Troy Schools District

**RFP #2324-22
BP#3B Smith Middle School - ARCH & MEP & Civil -
Addendum #2
July 15th, 2024**

Troy Schools District – BP#3B Smith Middle School – ARCH & MEP & Civil – Addendum #2

Addendum #2 Bidder Clarifications

PROJECT NO.
22102
DRAWING NO.
E0.6

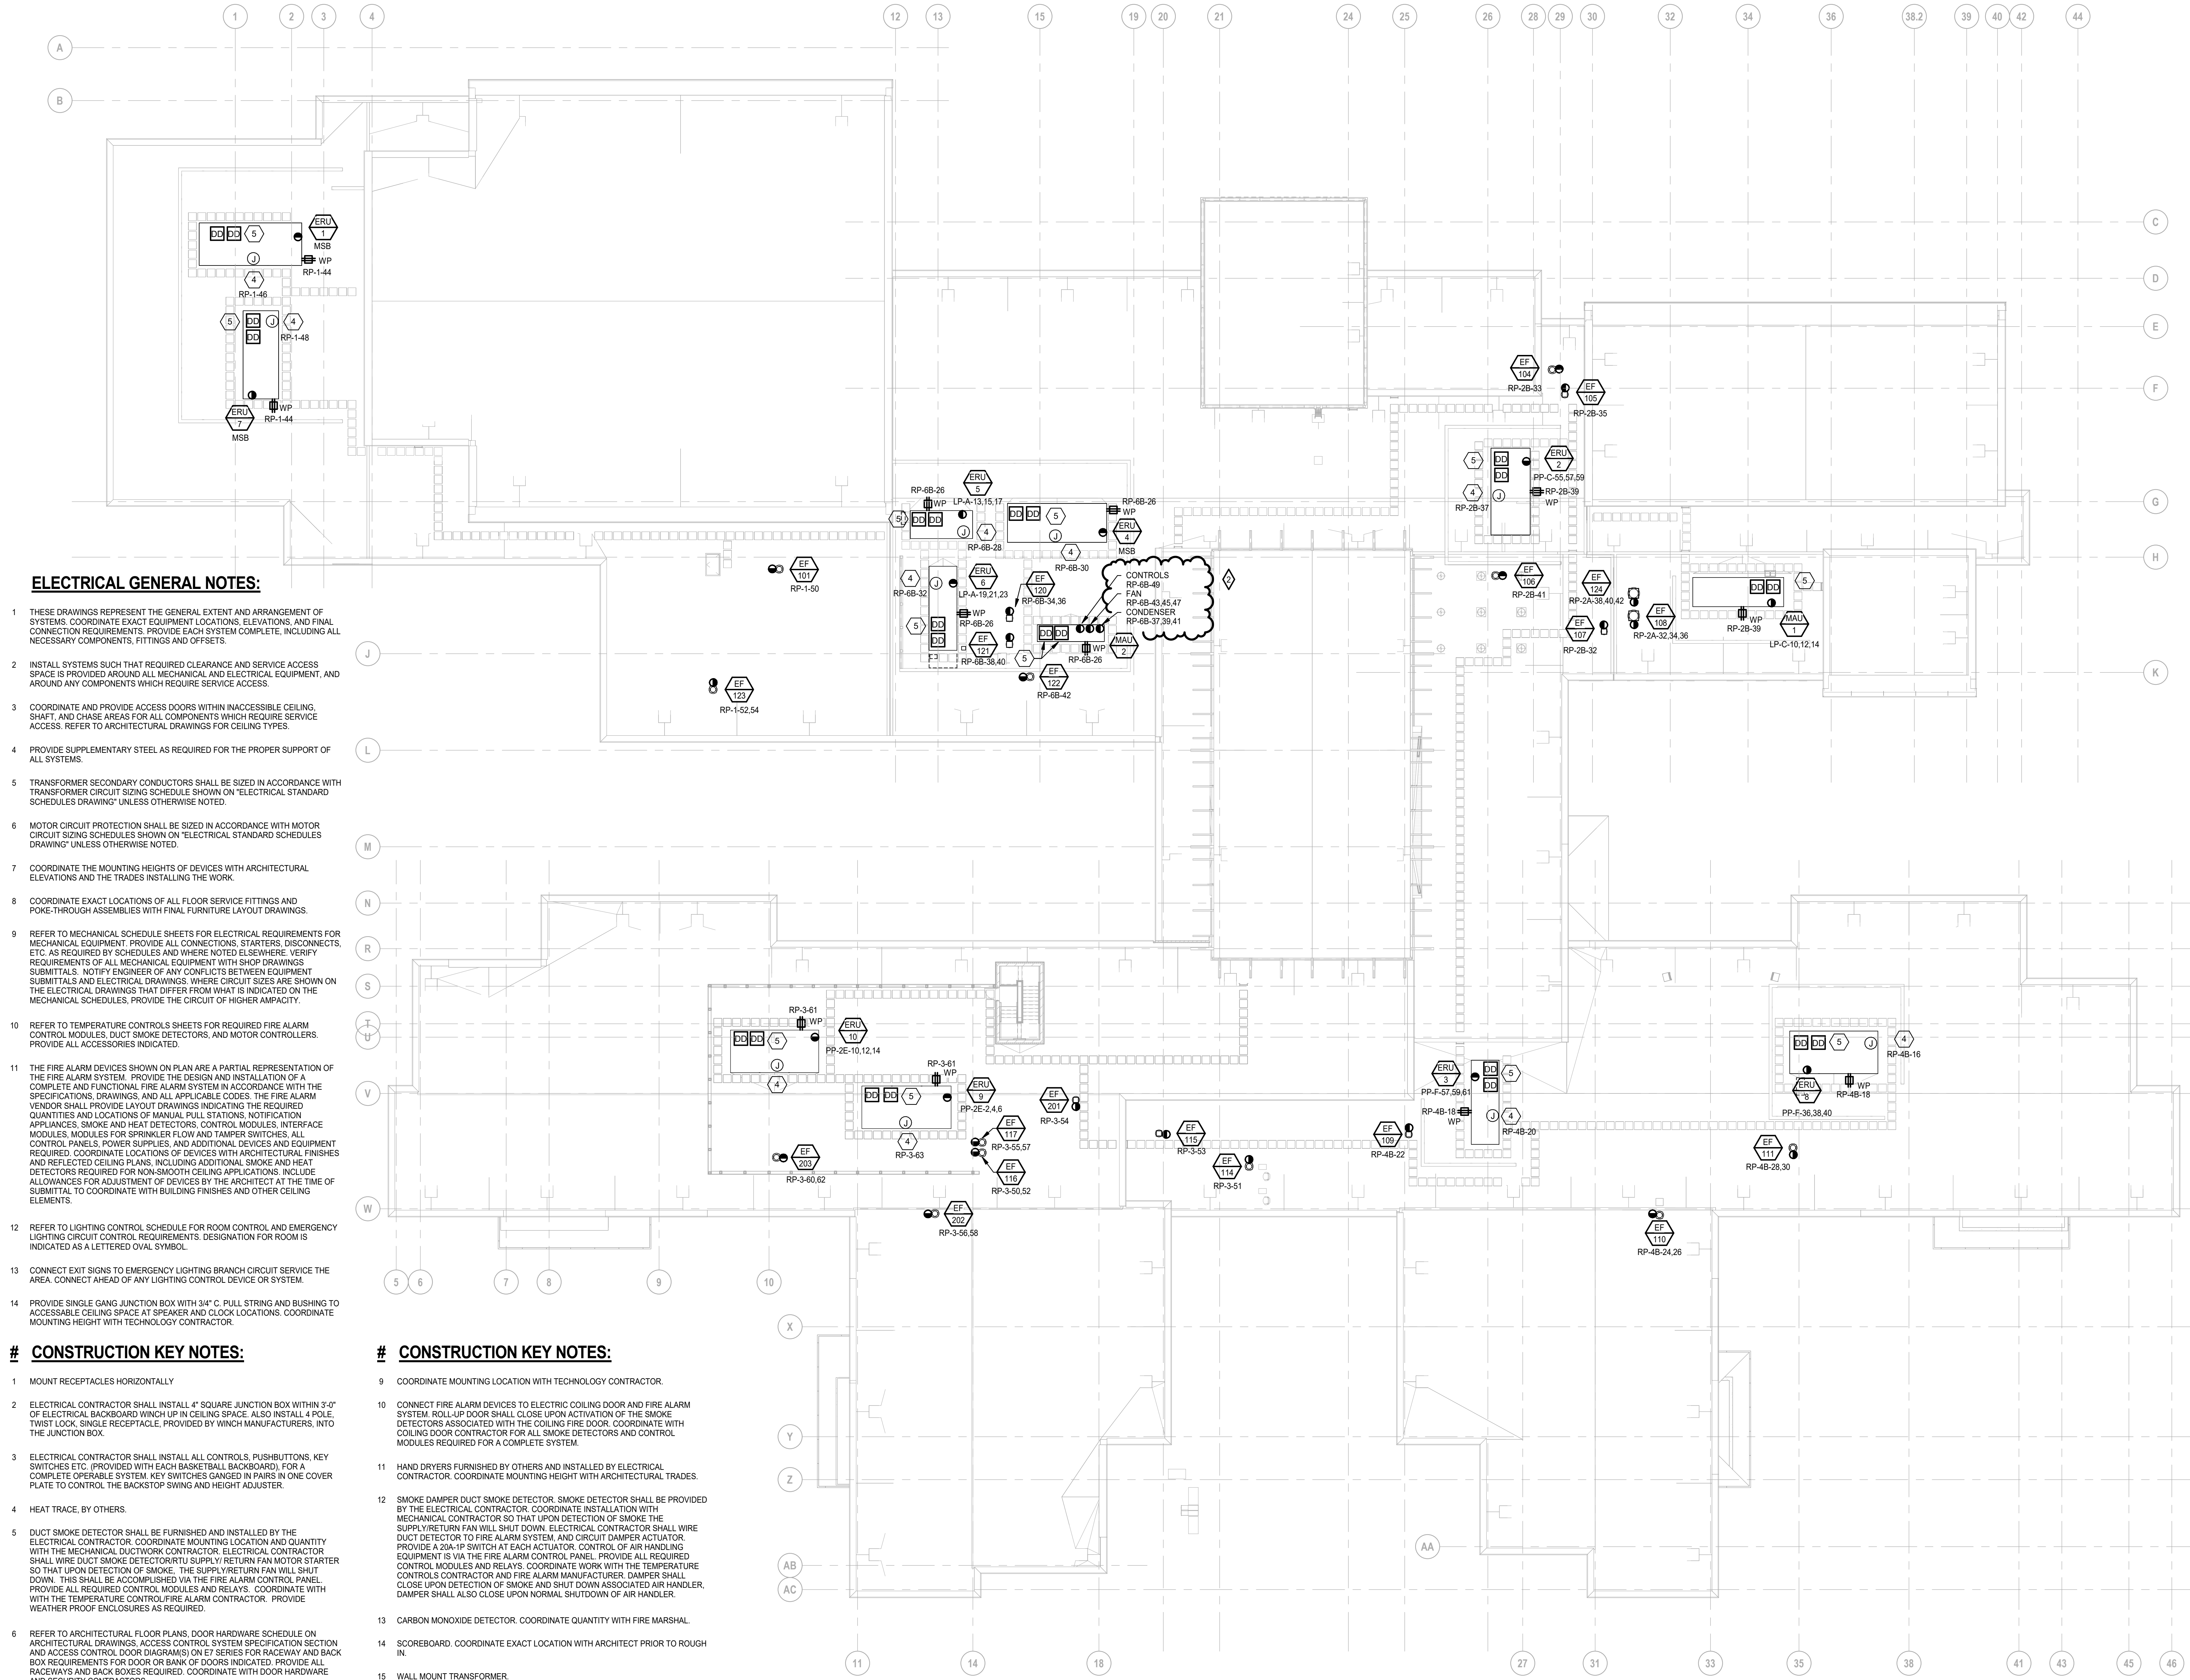
- ED-3 Refer to Drawing No. E0.6 (reissued):
- A. Revised circuiting to MAU-2.
